City of Weston Comments
Fort Lauderdale-Hollywood International Airport
Noise Assessment and Recommendations

This report supplements the City of Weston Comments Fort Lauderdale-Hollywood International Airport 14 CFR Part 150 Draft Noise Compatibility Program Comments and recommendations dated May 14, 2021. The purpose of this noise assessment is to conduct a simple noise analysis to quantify and verify noise impacts to the City of Weston and identify alternatives that may reduce aircraft noise impacts for residents of the City of Weston.

Figure 17 Profile View of 10 L Procedures

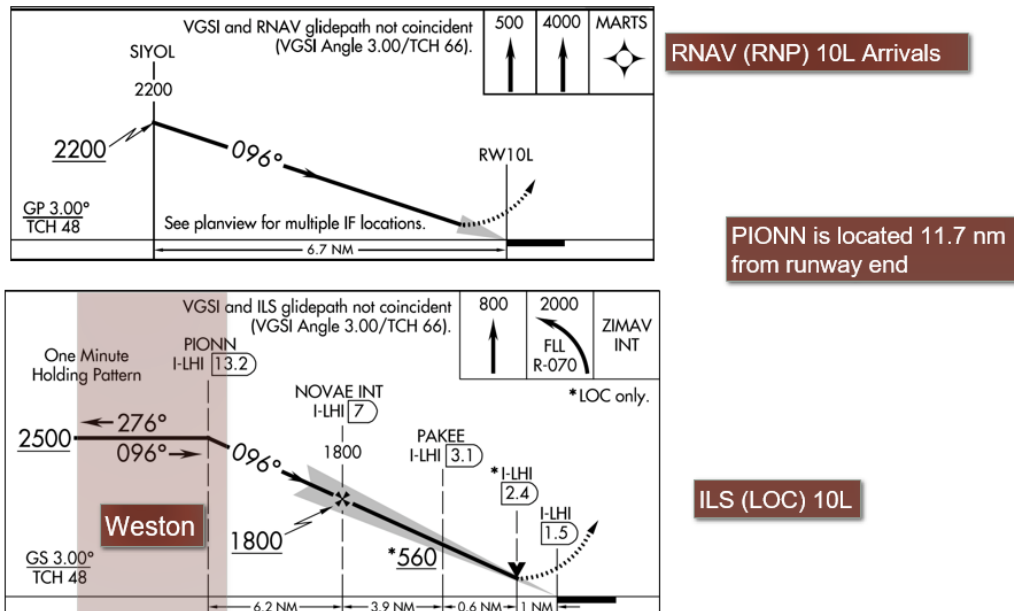
The profile view of flight track data demonstrates altitudes below what a normal 3 degree glideslope would predict at the east and west boundaries of Weston. These altitudes are consistent with the published approaches shown below.

- We recommend the adoption of recommendation NA-5 in the Fort Lauderdale-Hollywood International Airport 14 CFR Part 150 Study Draft Noise Compatibility Program Report (shown below)

Conclusions: NA-5: *Modify Aircraft Arrival Profiles to the West of FLL to Keep Aircraft Higher.* This measure could reduce noise levels outside the DNL 65 contour in residential areas west of FLL. The measure would involve modifying aircraft arrival profiles by raising the altitudes of aircraft transitioning from the downwind to the final legs in east-flow conditions. This measure would not reduce noncompatible land uses within the DNL 65 contour but could reduce annoyance caused by aircraft overflight in residential areas west of FLL.

Figure 30 South Central Florida Metroplex DNL Levels Weston

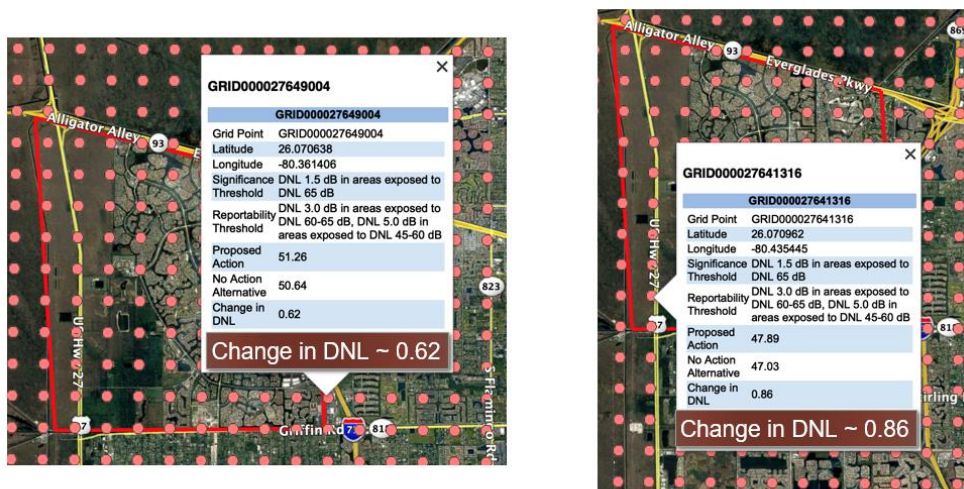
According to the South Central Metroplex Study the new departure and arrival procedures are expected to increase DNL noise levels at Weston by up to 0.86 dBA. DNL levels at the City of Weston are expected to be as high as 52.2 dBA.

Future DNL Noise Levels at Weston are Expected to Increase by up to 0.86 dBA (Southwest Corner of Weston under the Flight Path of Runway 10L)

Figure 34 Difference Between Baseline and Option 1

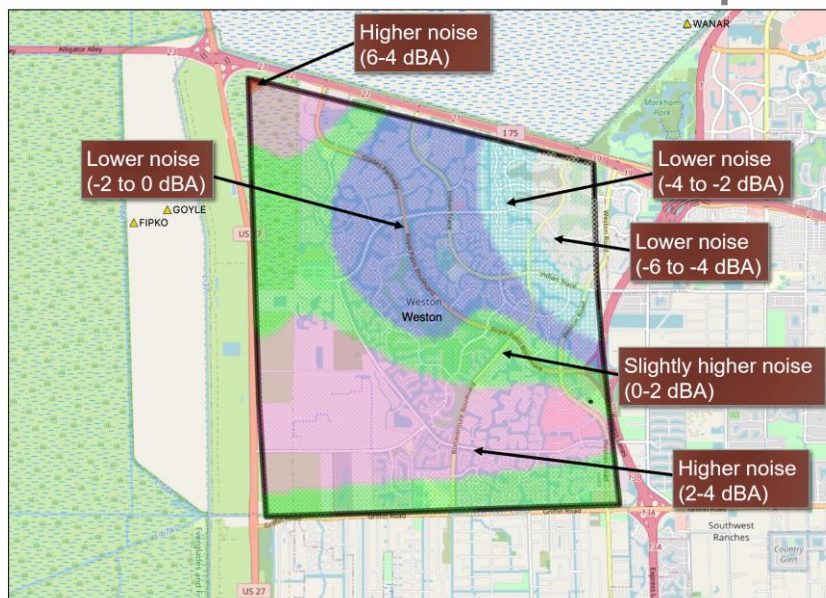
Option 2 Move all Downwind Flight Tracks 2 nm West of the Boundary of Weston
Option 2 results in similar increases to south Weston as option 1. Because south Weston is one of the higher overflight areas of Weston Options 1 and 2 are not recommended.

Figure 35 Profile View of East Flow Arrivals to FLL Over Weston

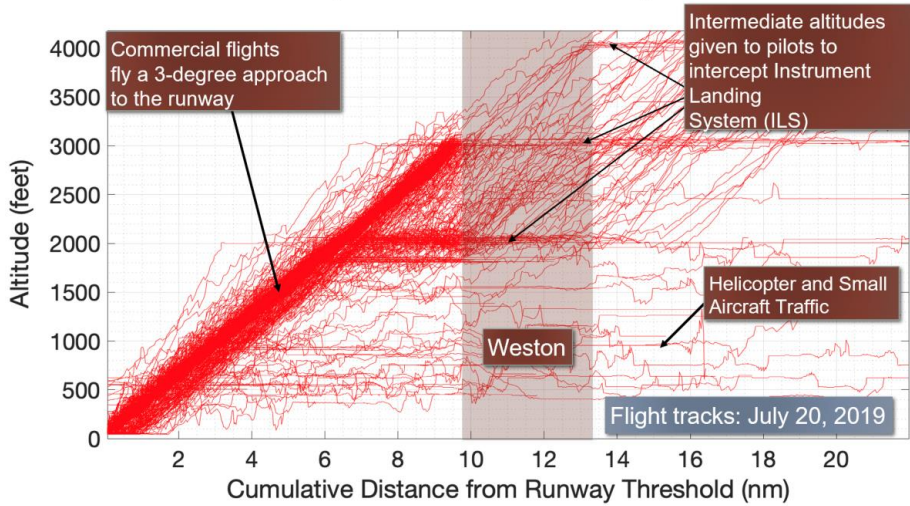
Option 4 Prescribe Steeper Approaches to Runways 10L and 10R
Current FLL approach altitudes in east flow are below the altitudes derived from a 3-degree approach (normal procedure) at the east and west boundaries of Weston.

This recommendation is to at minimum adjust waypoints to fly continuous descent on approaches to both runways 10L and 10R keeping aircraft on the 3 degree glideslope and raise PION to 3,300'. At a maximum, raise the necessary approach waypoints to fly continuous descent on approaches to a 3.5 degree glide slope to runways 10L and 10R.

Figure 39 Option 4 Noise Reduction with Higher Altitudes over Weston

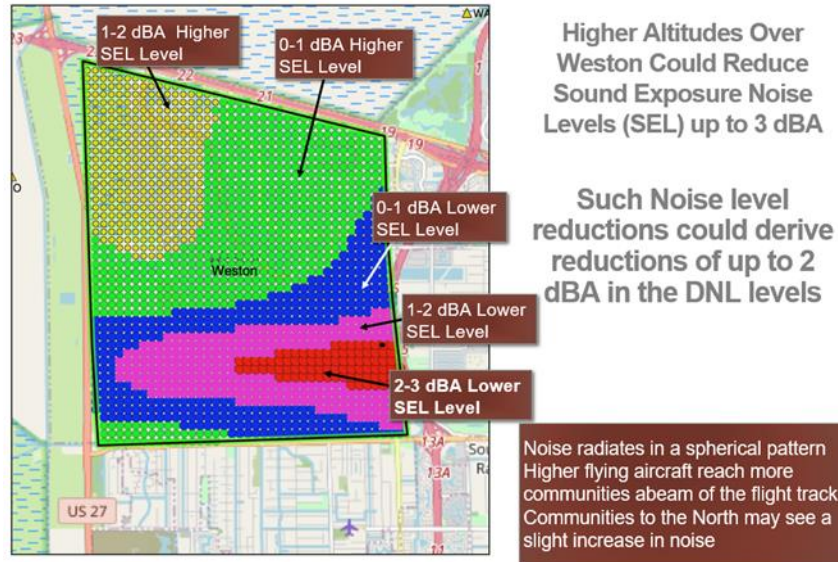
The simulated effect of imposing higher altitudes for straight in flights over Weston results in 500 feet higher altitudes on average compared to observed flight tracks. This

resulted in a 2-3 dBA maximum SEL reduction (or approximately 1.5-2 dBA DNL reduction).

Option 4 is recommended as an alternative to propose to the FAA with additional analysis to understand future vertical flight profiles of future metroplex flight tracks and revise accordingly.

Figure 40 New ILS Arrival Procedures for 10L November 2021 Raise Altitudes over Weston

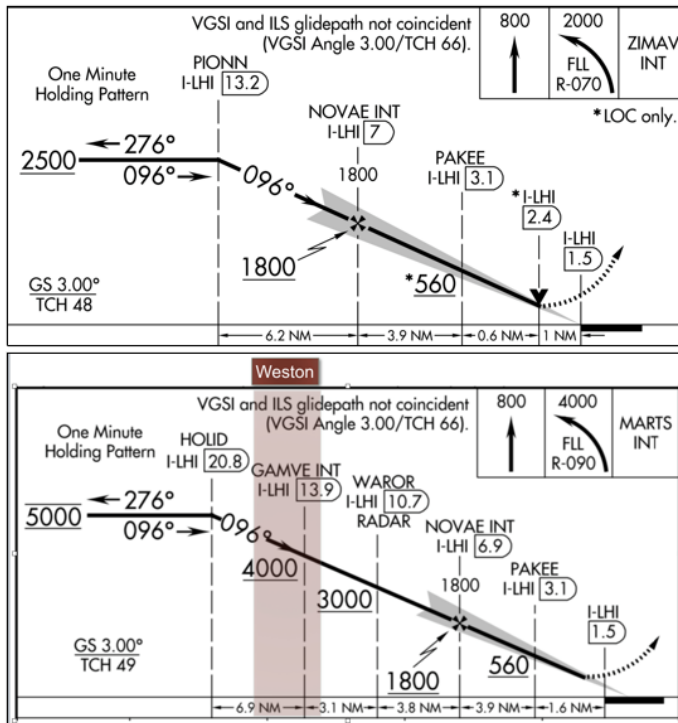
Note: The FAA implemented Option 4 during the study raising the ILS arrivals on 10L and 10R by 1,200-1,800 feet.

New ILS Arrival Procedure to Runway 10L Reduces Noise Over Weston by Increasing Crossing Altitudes by 1,200 to 1,800 feet

The new descent profile stated in the ILS forces aircraft to cross the City of Weston between 4,400 and 3,300 feet based on a descent gradient of 325ft/nm. The new altitudes over the City of Weston will help mitigate noise by 1-1.5 dBA

Figure 41 FLL 10L RNP/RNAV Procedure

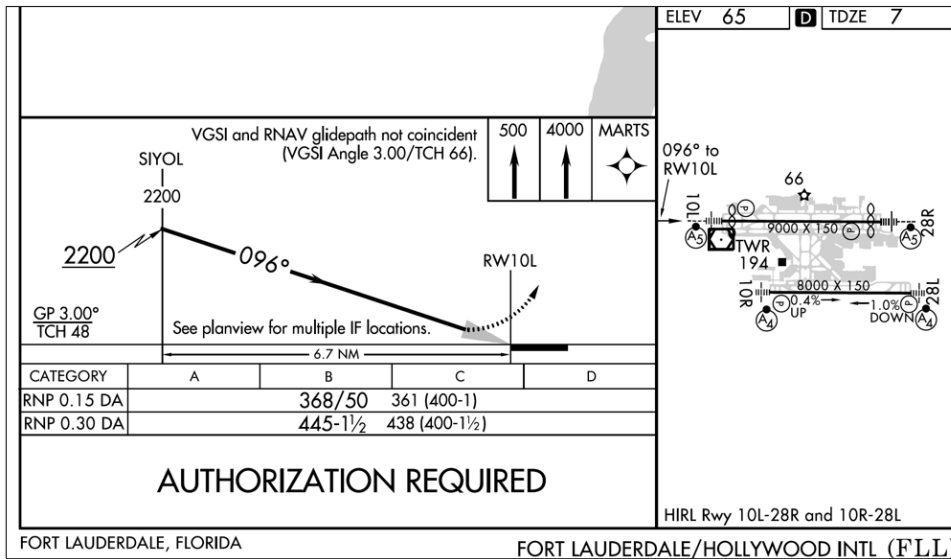
Option 6 recommends utilizing the existing RNP RNAV 10L procedure for nighttime arrivals. It provides for complete relief to all of Weston for 10L operations at night. Option 6 is recommended to move forward as an alternative to propose to the FAA.

Figure 42 10L RNP/RNAV Procedure Relative to OLAHS RNAV STAR

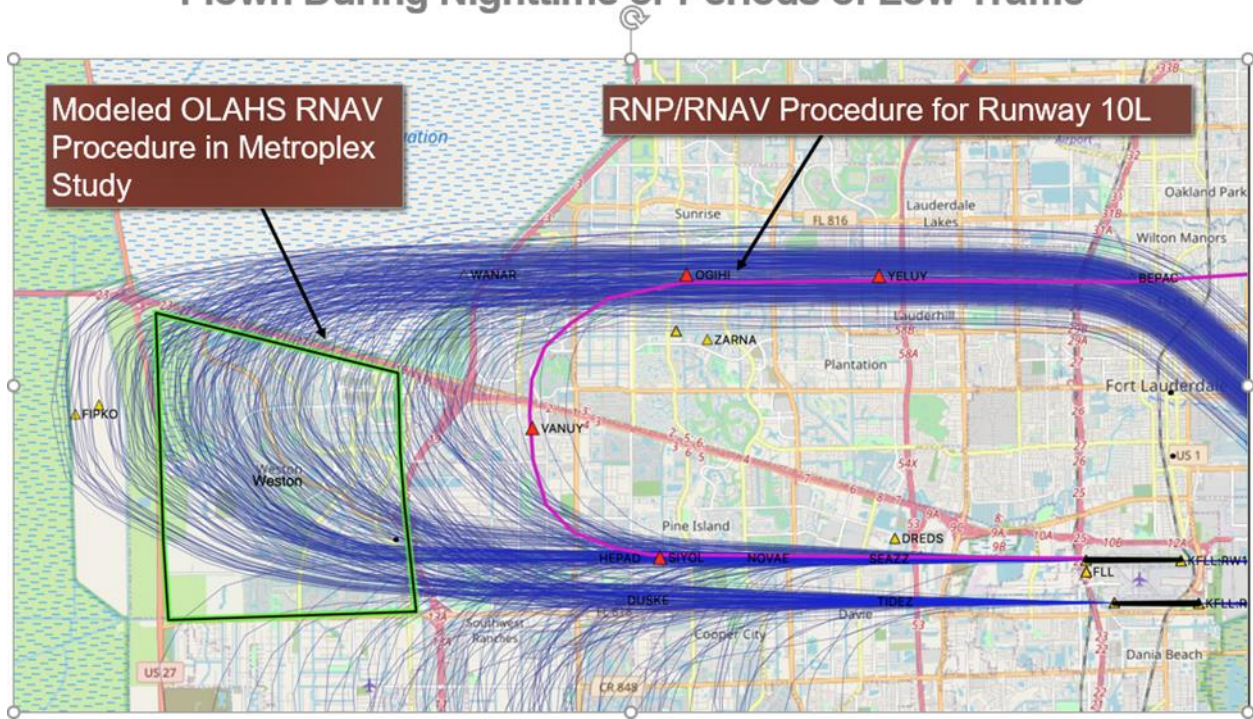
Weston Could Benefit if the RNP/RNAV 10L Procedure is Flown During Nighttime or Periods of Low Traffic

Figure 43 Option 7 Noise Analysis

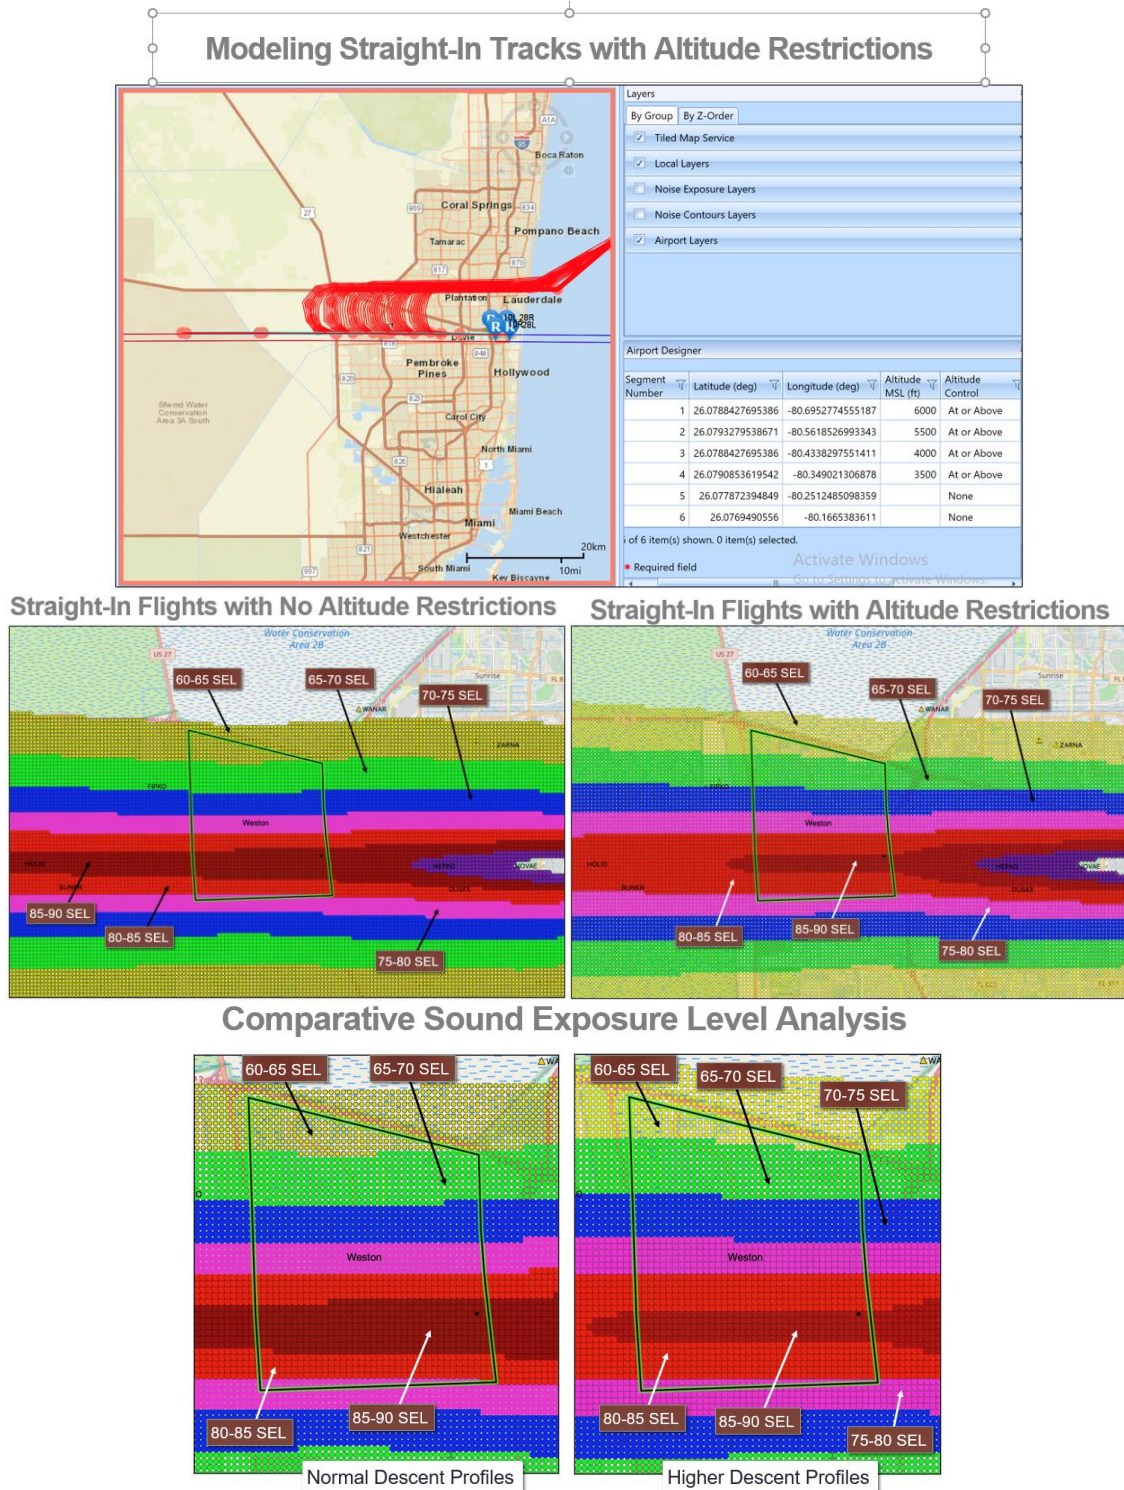
Option 7 produces small reduction of noise impacts for north and middle Weston but arrivals to 10R still overfly south Weston. Option 7 is not recommended.
